OHIO TURNPIKE AND
INFRASTRUCTURE COMMISSION

ADDENDUM NO. 1

PROJECT NO. 39-16-01 (PART A)
RIGHT TWO (2) LANES AND SHOULDER RECONSTRUCTION
MILEPOST 107.3 TO MILEPOST 112.5
ERIE COUNTY, OHIO

PROJECT NO. 39-16-01 (PART B)
BRIDGE DECK REPAIR & REHABILITATION
OHIO TURNPIKE OVER NS RAILROAD AND KELLY ROAD MILEPOST 117.3
OHIO TURNPIKE OVER US ROUTE 250 MILEPOST 118.1
ERIE COUNTY, OHIO

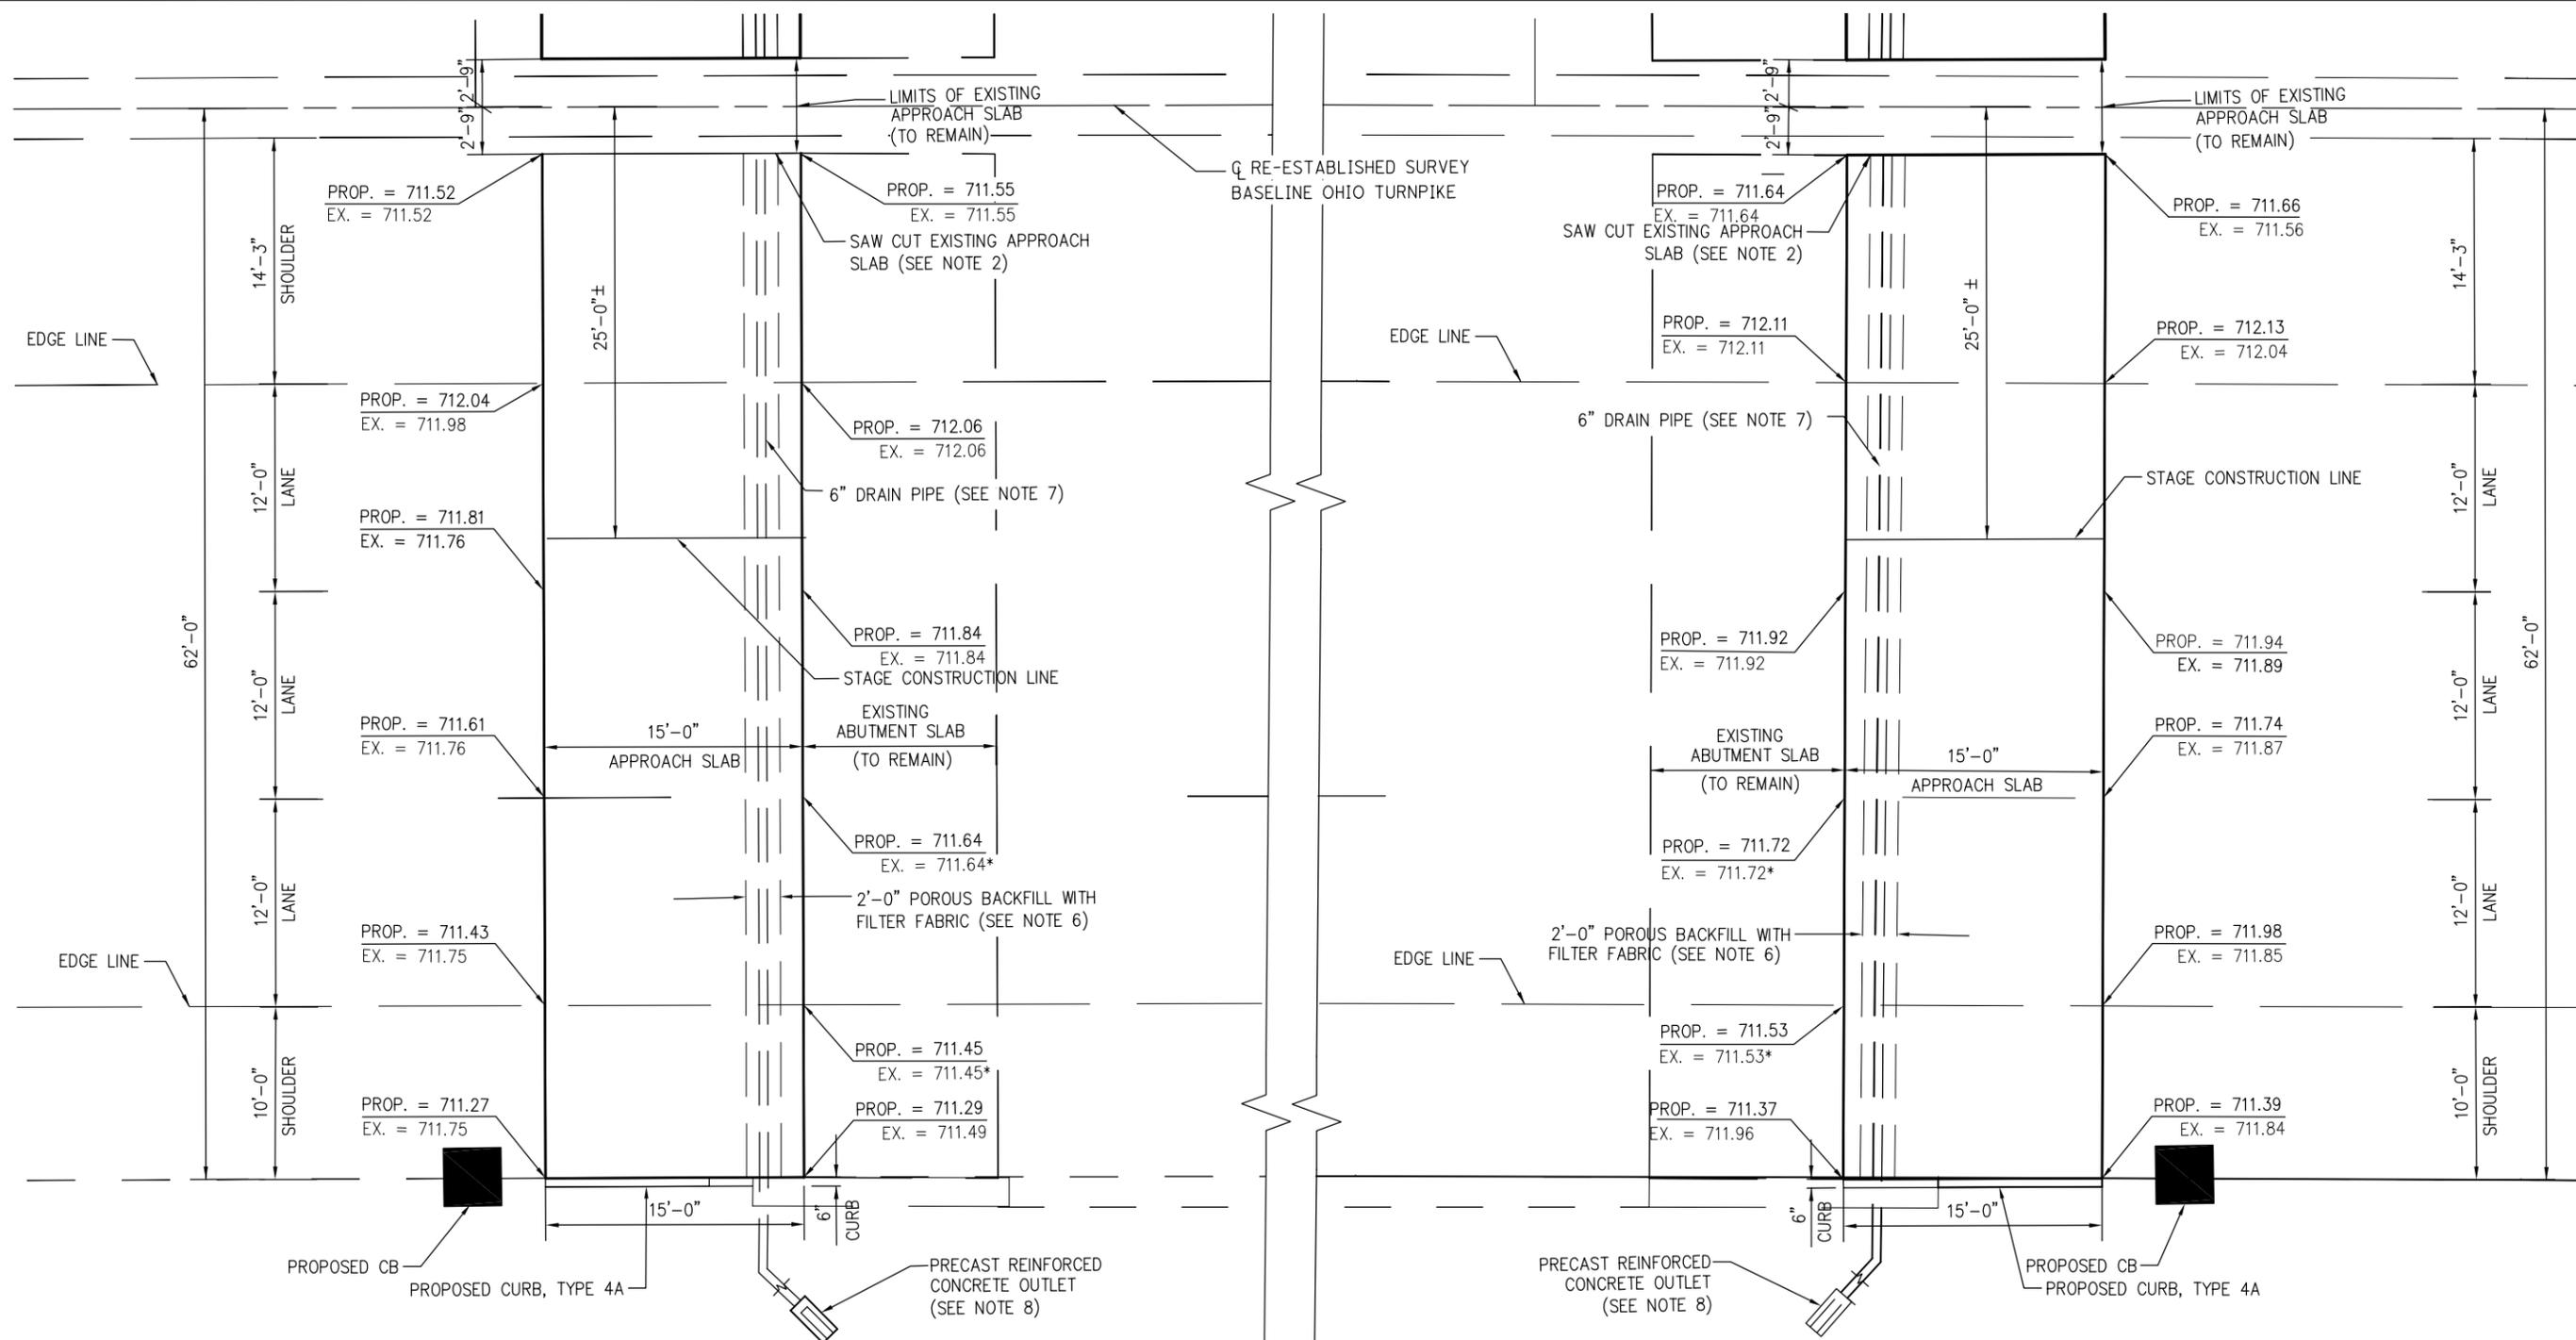
Q#10 Bid items 59, 61, and 67 (partial): plan sheet 238 has a note describing the purpose for these items, but no standard drawing and/or breakdown of how many areas, dimensions, locations, etc. has been provided. Please provide better and more concise information (such as whether in ditch line, on slopes near bridges, etc.) on these items given their dollar value.

A#10 *This Addendum No. 1 modifies the "Vegetative Filter Strips and Biofilters" General Note on Sheet 238 of 432. The criteria for a vegetative filter strip is a vegetative slope that has a width of 15 feet or greater from the edge of berm to the inside edge of ditch bottom or a slope steeper than 3:1. This vegetative slope shall be 3:1 and flatter with an 80% Vegetation or greater. The Project goal is 3 miles of a 15 foot wide Vegetative Filter Strip and estimated quantity of 6" of topsoil is provided for 50% of the Project goal Approach slab and Bridge slopes will not be considered a Vegetative Filter Strip. See the modified General Note for more details*

APPROACH SLABS FOR MILL CREEK BRIDGE, EASTBOUND

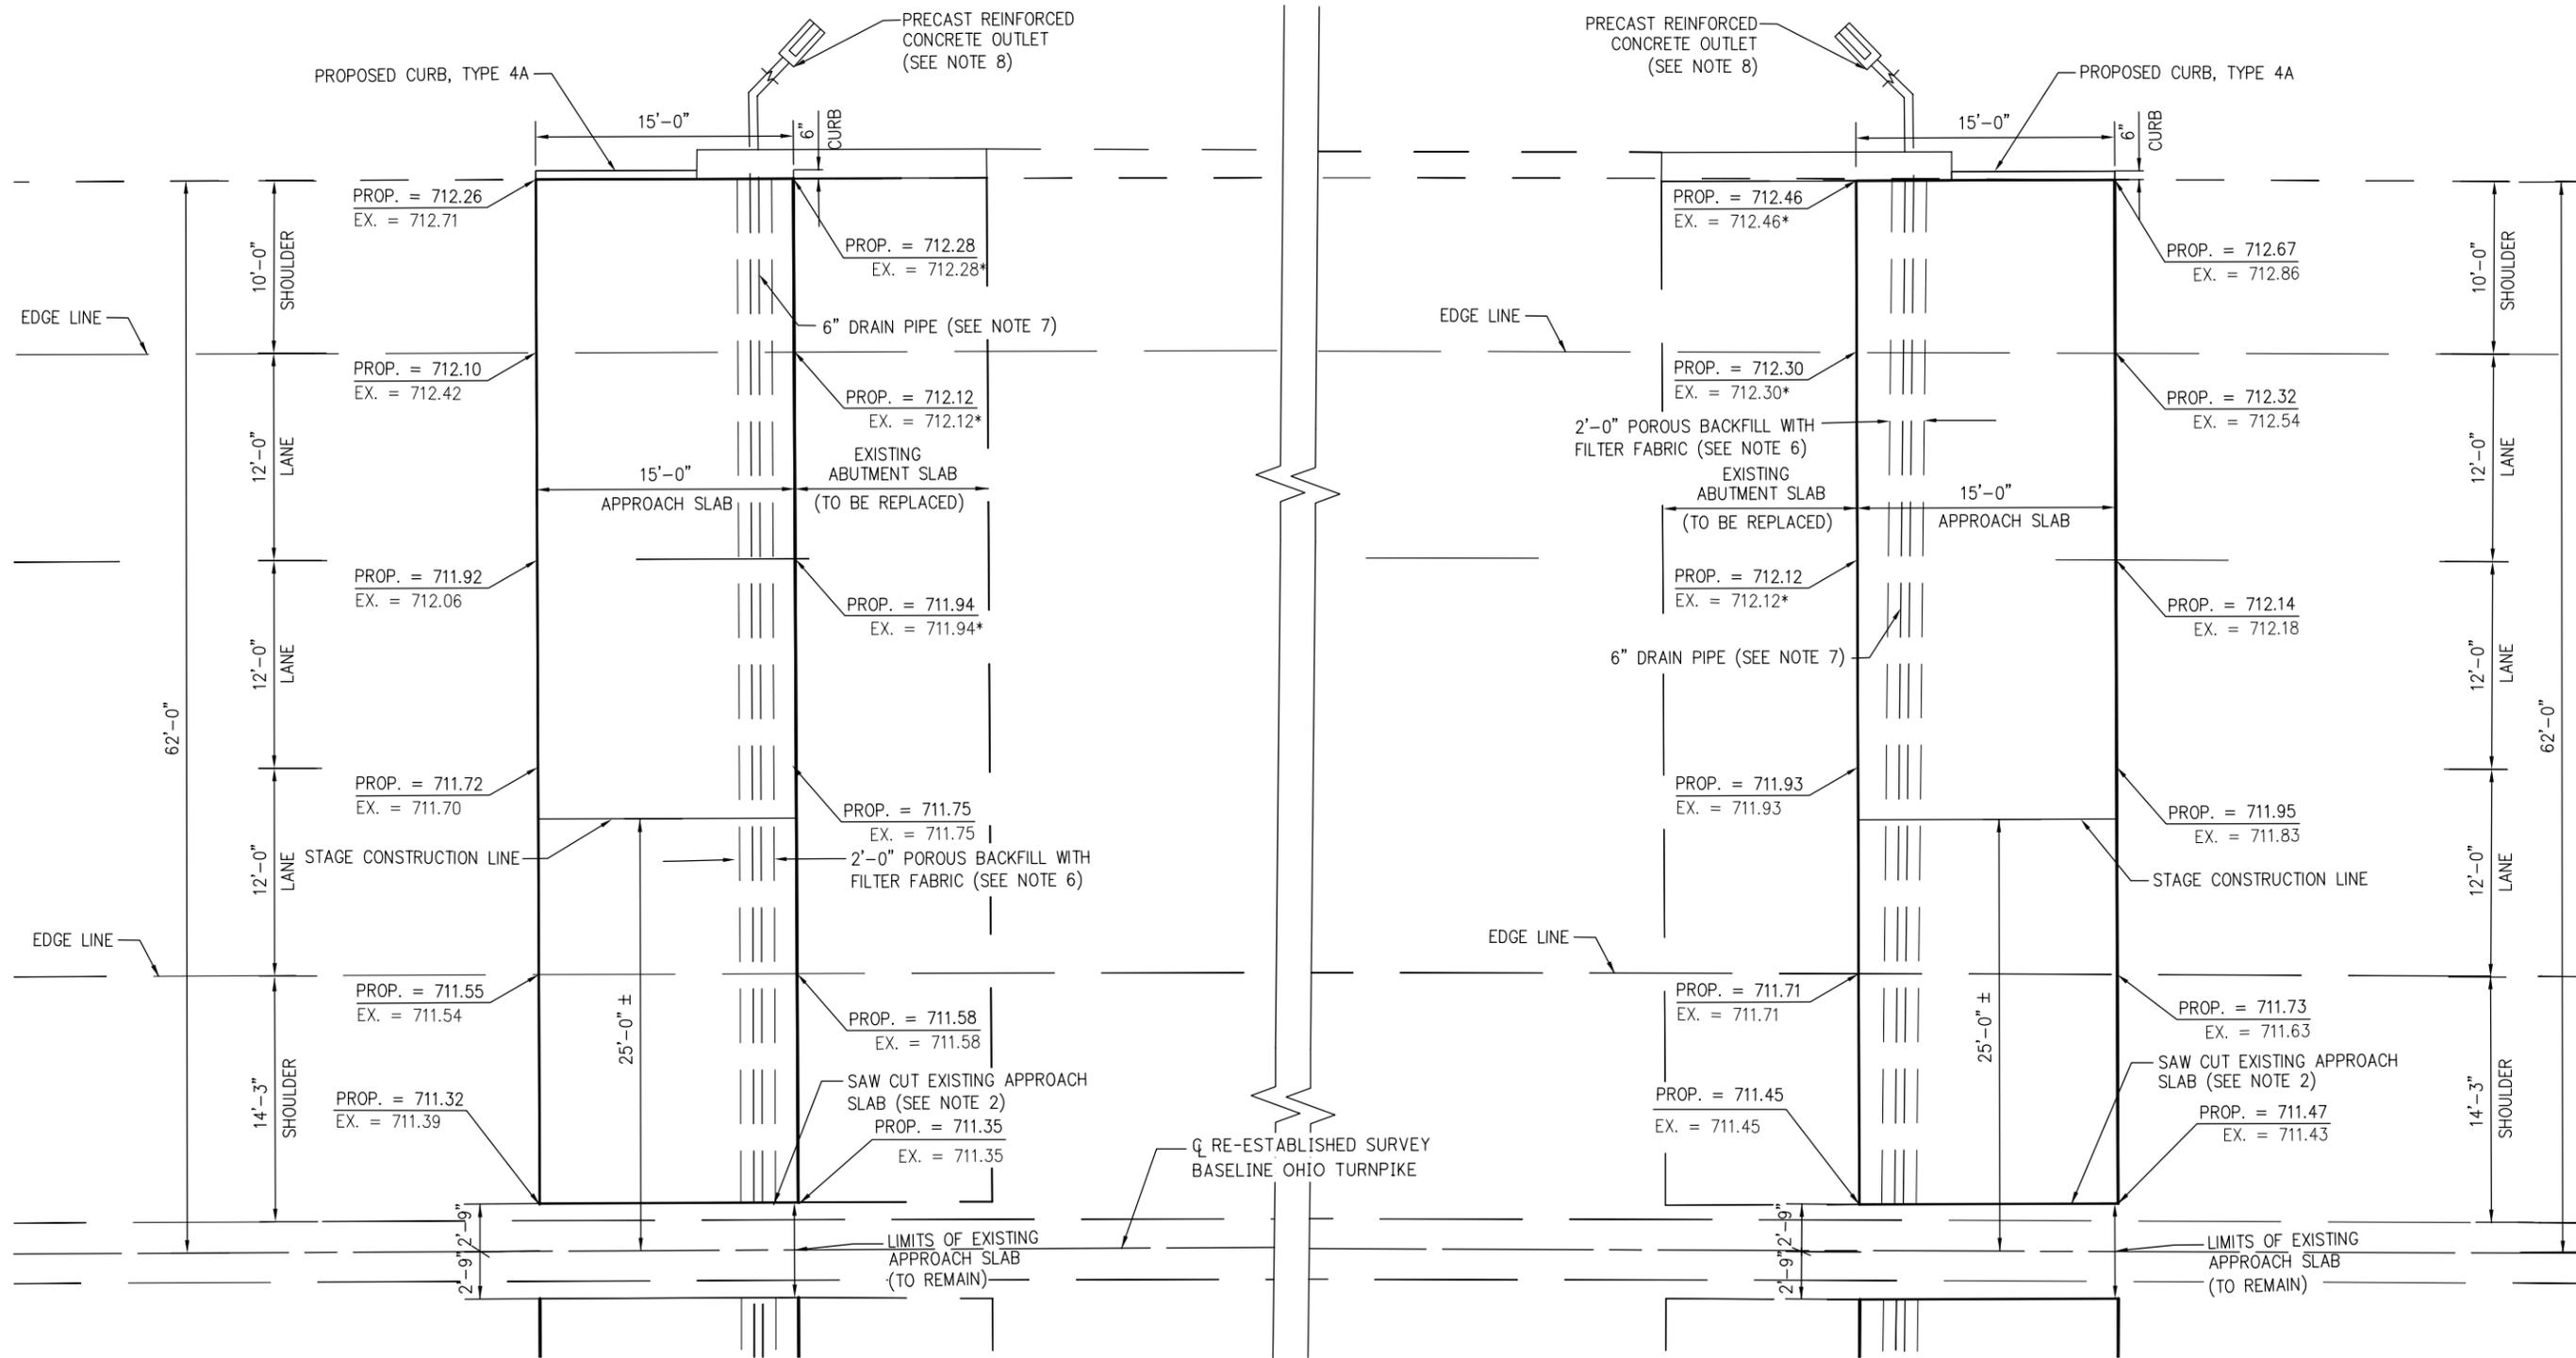
Q#4 Sheets 375-384 - Note 7 shows the installation of a 6" drain pipe per OTIC SD AS-5. Neither the plans, nor AS-5 show the depth of the drain. Please specify drain depth.

Q#5 Sheets 375-384 show the installation of 6" drain pipe per OTIC SD AS-5 directly behind the abutment backwall. However, various locations in the plans call for the installation of a parapet wall that extends behind the backwall and below grade. Can the drain pipe be directed under or around the parapet wall or does the drain pipe need to extend straight through the parapet wall?

A#4 OTIC Standard Drawing AS-5 shows the drain pipe at the bottom of the grade beam. The depth of the grade beam bottom below the approach slab bottom varies. Record OTIC bridge plans for construction completed in the 1950's, 1980's and 1990's within the this project's limits show or scale the following depths: Mill Creek +/- 4'-0" to +/- 4'-6"; NS RR, +/-2'-8" to +/-3'-7"; Portland Road +/-3'-2" to +/-5'-1"; SR 99: +/- 3'-0" to +/- 3"-7".

A#5 The 6" drain pipe is located behind the existing grade beam. The alignment of this 6" drain pipe shall be kept straight behind the grade beam and shall outlet into the embankment slope as shown on Sheets 375 through 384 of 432 of the plans. The Contractor shall drop this drain pipe under the two proposed parapet walls at the Mill Creek bridge, shall drop this drain pipe under the two proposed parapet walls at the NS Railroad bridge and drop this drain pipe under the three proposed parapet walls at the SR 99 bridge. There are no conflicts with this drain pipe at the Portland Road Bridge
